Geotechnical Review

February 22, 2024

Subject: Response to County of Los Angeles Comments
Dated November 8, 2023
Proposed Lyons Canyon Development
Tentative Tract Map 83301
Los Angeles County, California

Scale: 1"=100' Date: 9/15/2023 Drawn By: JH Figure 1 Checked By: GAL Date: 2020-200-001

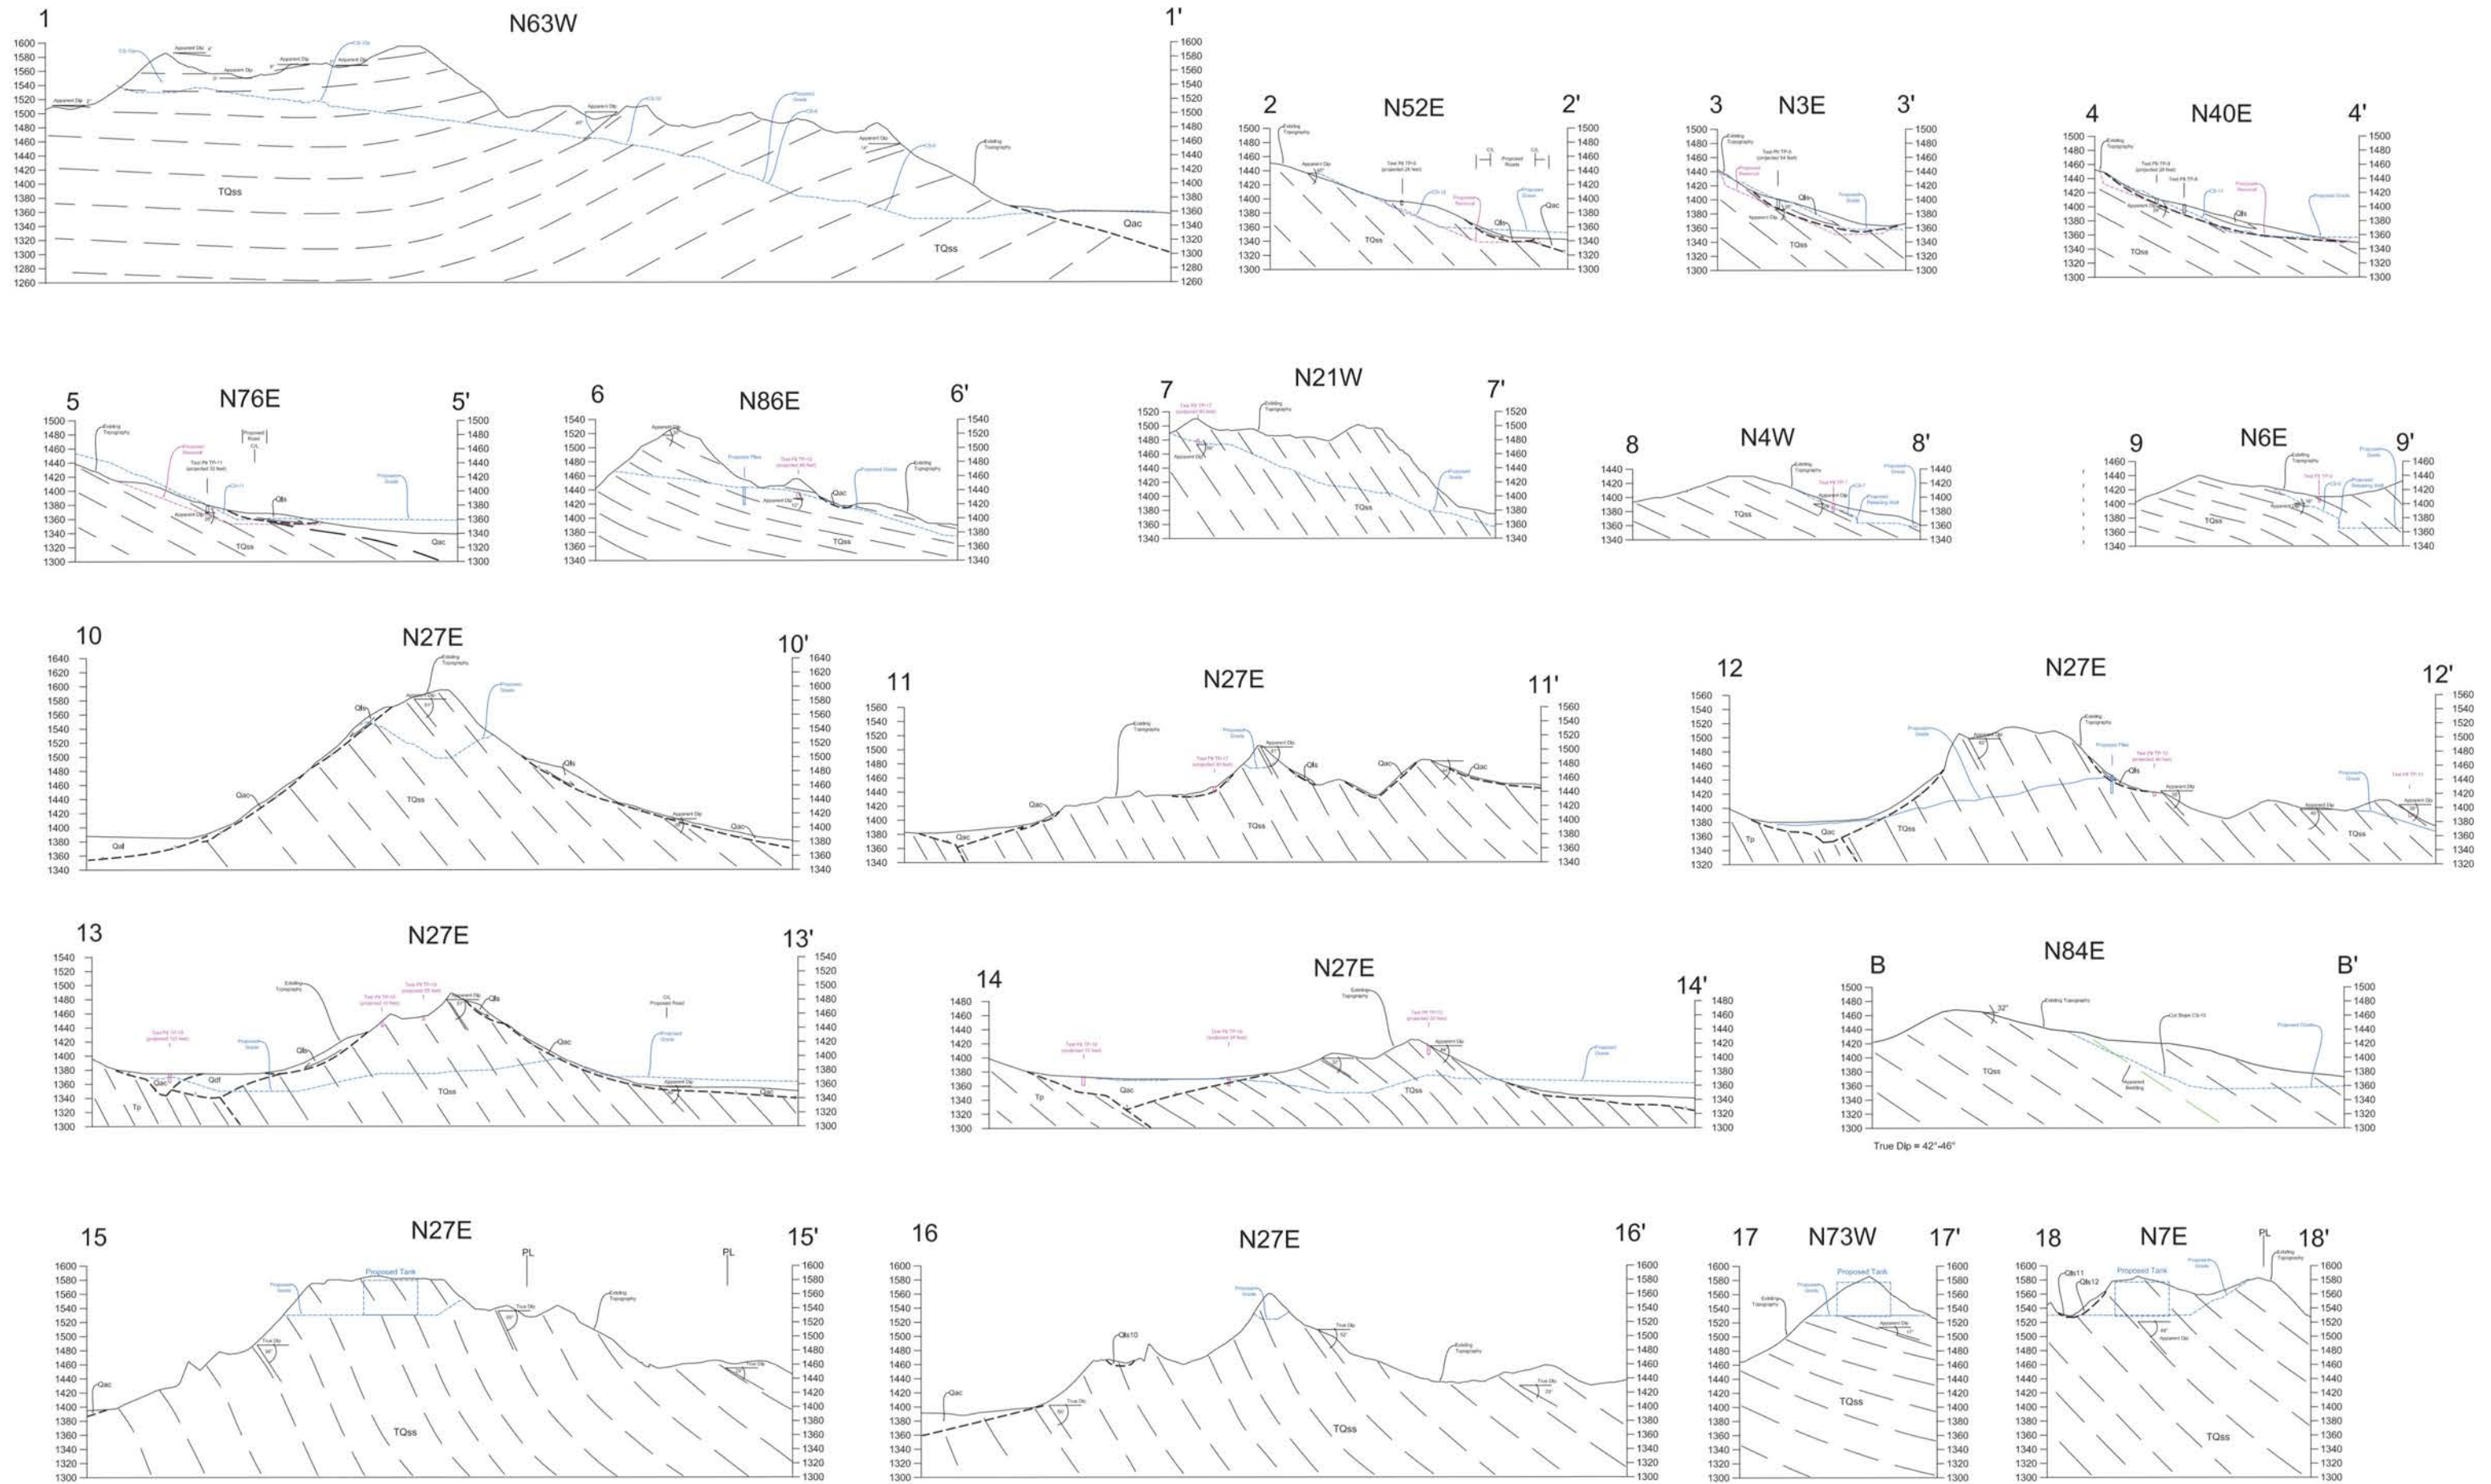
G1. Several landslides are mapped on the slopes below the proposed water tank. Verify that landslides illustrated on Figure 1 will be removed and/or mitigated. Show limits of removals on geotechnical map and/or other mitigation measures.

G2. Please show the location of the abandoned oil well on Figure 1.

This comment was discussed with the GMED Geology reviewers during a virtual meeting where new Geologic Sections were presented and in addition to addressing the original comment, slope stability calculations were also requested.

Slopes associated with the proposed water tank pad are generally steep, often with slope ratios steeper than 1 horizontal : 1 vertical (H:V), and in many locations steeper than .5H:1V. Hard conglomeratic sandstone beds between 8 feet and 40 feet thick have facilitated the steep slopes, ledges, cliffs, and hogbacks, are not prone to be involved in landslides, but rather hold the slopes up, limiting the extent of and orientation of slope instabilities in the area. Field mapping and interpretation of aerial imagery from 1930 to the present 2017 with select images presented as Figures HA-1 through HA-4 undoubtedly indicate that there is no geomorphic expression of any deep seated slope failures or landslides on the slopes of the proposed tank pad or in the vicinity. Furthermore, it is absolutely apparent that site slopes are intact as the stratigraphy favorably crosses the area of the proposed cut.

Therefore, the features previously labeled as landslides Qls11, Qls12, Qls13, and Qls14 have been relabeled and are classified as surficial slumps labeled as SS1, SS2, SS3, and SS4 (respectively) on Figure 1(R). Geologic Cross Sections 19-19', 20-20', 21-21', and 22-22' have been constructed and are presented as Figure 2.1, along with Geologic Cross Sections 13-13' through 18-18' which have previously been submitted.

Grading of the water tank pad, as proposed, will remove roughly 40 to 60 feet of rock from the ridgeline. This proposed grading will remove the steepest parts of the slopes that include the heads of the four mapped surficial slumps. This alone will mitigate further advancement or encroachment of surficial degradation into the proposed water tank pad. Each surficial slump, SS1, SS2, SS3, SS4 is discussed individually below, and identified on Figure 1(R). Each of these slumps are not deep seated features, but rather are surficial in nature, with SS3 and SS4 being considered creep features. The proposed grading does not adversely impact the stability of the existing slopes, it improves it.

Surficial Slump SS1 is surficial sloughing involving colluvium and weathered sandy mudstone on a dip slope that is structurally controlled by hard well cemented hog back forming conglomeratic sandstone. Proposed grading will remove the top of SS1 and leave debris on the slope below the cut to function as armor. Proposed grading will reduce water on the slope. Grading of the water tank pad will improve the conditions of the slope. Surficial Slump SS1 does not pose a negative impact to the water tank pad. No slope specific mitigations are necessary or recommended.

Surficial Slump SS2 is a collection of coalescing shoots generated on the antidip slope within sandy mudstone situated below a ledge forming well cemented cobbly sandstone, not the same hard sandstone bed associated with SS1. The shoots are shallow accumulations of materials with a maximum estimated thickness of 8 feet. Proposed grading will remove the heads of the shoots and the majority of the sloughed materials. Grading as proposed will reduce the natural accumulation and focusing of water into the shoots thereby improving the slope's overall condition. Grading as proposed will mitigate SS2's potential for encroachment or impacts to the proposed water tank pad. No slope specific mitigations are necessary or recommended.

Surficial Slump SS3 is an accumulation of colluvium and weathered rock that is creeping down slope. The top of SS3 is generally at the elevation of the water tank pad. Estimated maximum thickness of the slide debris is 8 feet. Proposed grading will improve the condition of the slope and reduce the volume of water on the slope. No specific mitigations are necessary or recommended for SS3.

Surficial Slump SS4 is a coalescing of small surficial slope failures and creep of colluvium and weathered rock. This complex is in a stratigraphically similar position as SS2. The top of SS4 is generated from very steep (.25:1 H:V) slopes at elevations generally above the proposed water tank elevation. Below an elevation of about 1520 the thickness of accumulated material on the slope is estimated to be about 8 feet while at the base of the slope the debris thickness is estimated to be up to 15 feet thick. Proposed grading for the water tank will remove the upper portions of the slope that are sloughing and creeping downward. Grading will reduce water on the slope improving the overall slope condition. No specific mitigation measures are necessary or proposed for SS4.

Acknowledged, see Figure 1(R).
